Copeland area Planning Department, Cumberland Council

CONSULTATION ON PLANNING APPLICATION

Appn: 4/25/2110/0F1
Site Address: LAND AT PARKSIDE ROAD, CLEATOR MOOR
Proposal: ERECTION OF 95 DWELLINGS WITH ASSOCIATED INFRASTRUCTURE

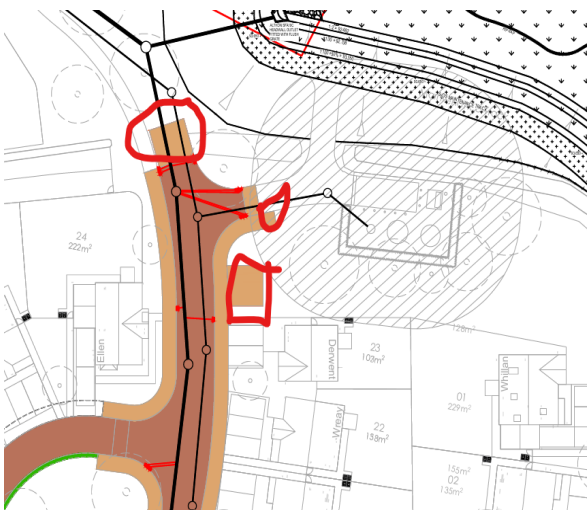
2. The visitor parking provision is acceptable in terms of locations and numbers. But the car parking per dwelling (in curtilage) is still not consistent and the lack of three spaces on some driveways may cause additional problematic on-street (and on-footway) parking. All 4 bedroom houses should have 3 driveway parking spaces. I appreciate that these have garages, but in our experience garages are not used for parking in most instances and used for storage instead.

I note some of the 4 bedroom plots have 3 spaces shown. However, many still only have 2 spaces. Please provide three parking spaces for plots: 08, 24, 32, 41, 45, 56, and 88. Alternatively, provide more spaces in laybys on the carriageway. A lack of parking will lead to more footway parking with an impact of amenity and road safety to pedestrians and wheelers.

Access and Visibility onto the A5086

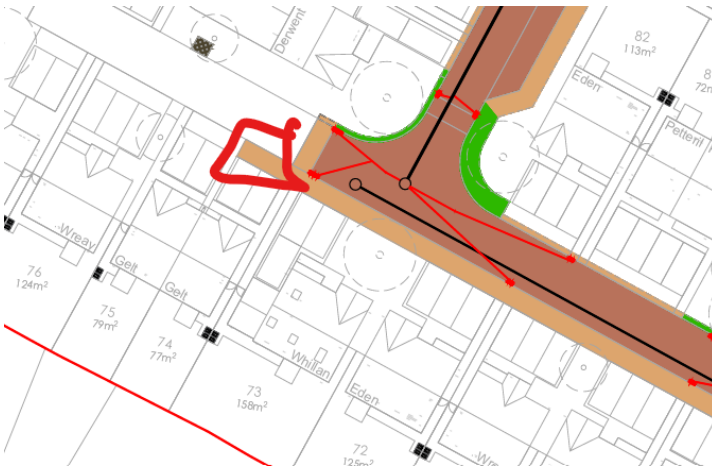
3. *The A5086 is a high speed improved, wide derestricted road. I note the proposal to move the 30mph speed limit to the far side of the proposed new access which is necessary (distance to be agreed). The A5086 does not conform to MfS principles so adopting a 43m splay is not considered appropriate and the more robust 60m should be applied. Please revise the visibility splay drawings to show 2.4m x 60m in each direction from both accesses.*

This has now been shown satisfactorily
